Author Response to Reviews of

Inter-model differences in 21st Century Glacier Runoff for the World's Major River Basins

Wimberly et al.
The Cryosphere

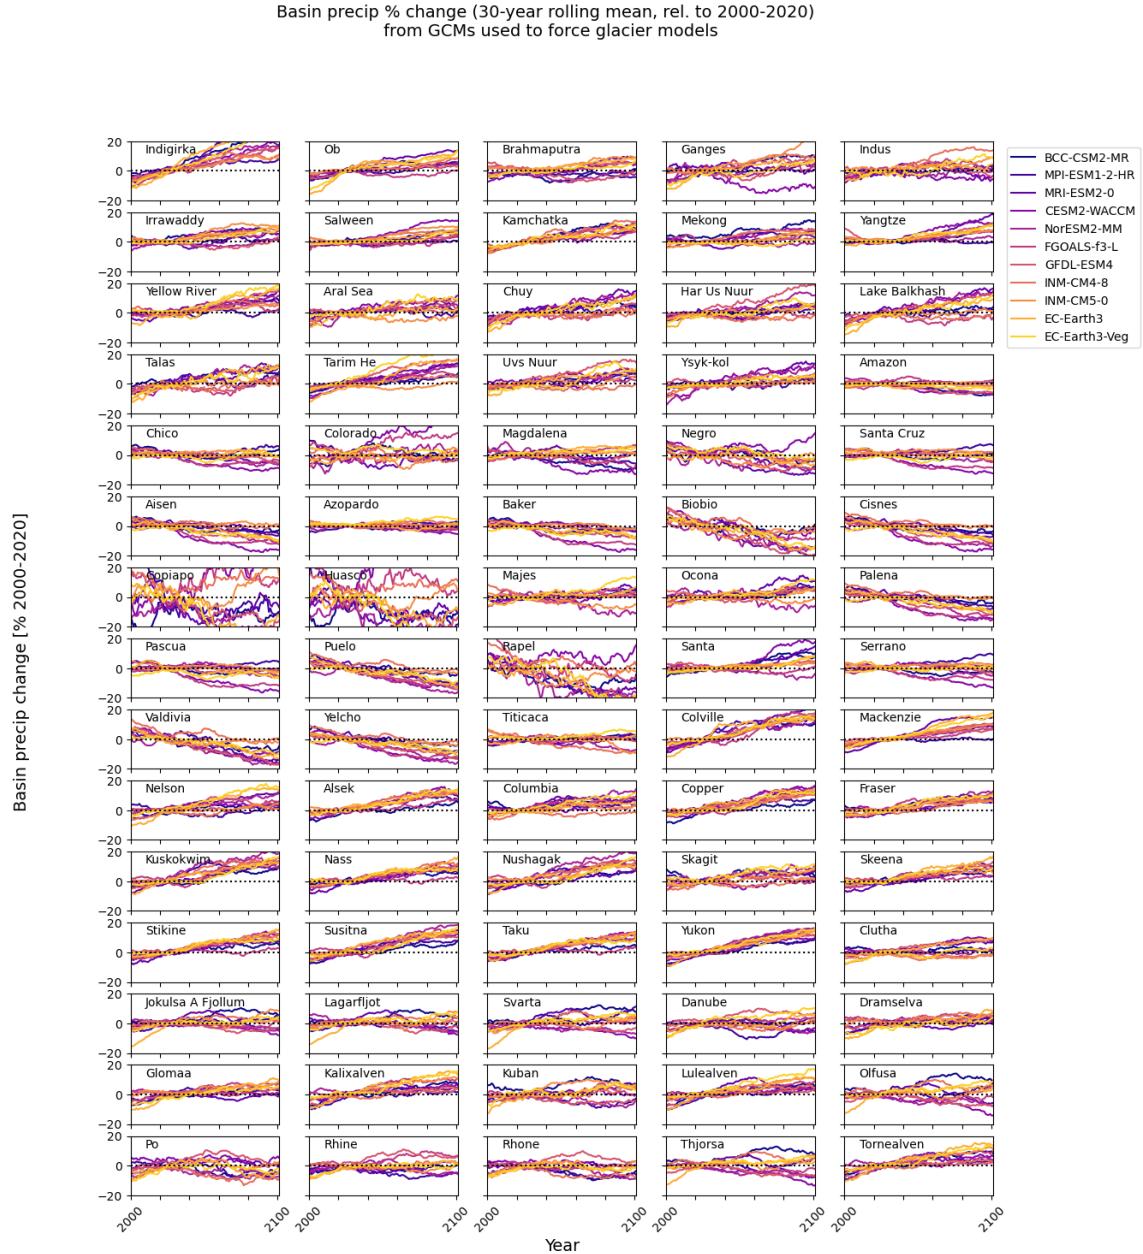
RC: *223: Is the range of increase from arid to maritime basins indicative of the precipitation trend?*

AR: *This is a very insightful thought. We did a preliminary analysis of the raw GCM precipitation trends, and we find it inconclusive. Figure below shows preliminary trends. The arid and maritime basins we identified with increasing seasonal peak do indeed all have increasing precipitation trend, as the reviewer suggested. However, other basins such as the Yellow River, Yangtze, and Uvs Nuur have an increasing precipitation trend but decreasing strength of glacier seasonal runoff. The magnitude of the seasonal increases and the precipitation increases are hard to compare across basins because we study them as percent change from a basin-specific baseline. This is another compelling analysis that would be made easier with the availability of partitioned runoff components. For now, we have not made changes to the manuscript in relation to this comment.*

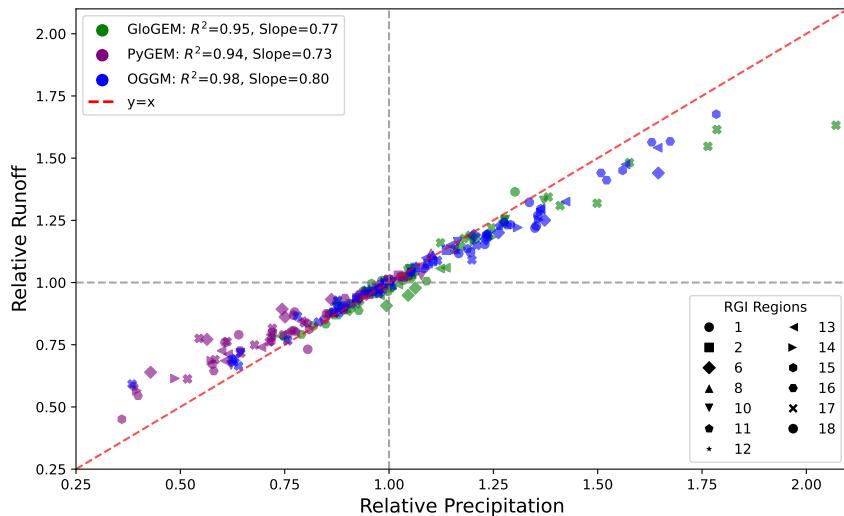
RC: *Figure 6: This figure illustrates the variation by model, would be useful to add to this figure a geographic domain using same color scheme but adding symbol variation.*

AR: *Thanks for this suggestion! This adds important information to the figure while maintaining its readability. We have incorporated this suggestion in a revised Figure 6 (see just below).*
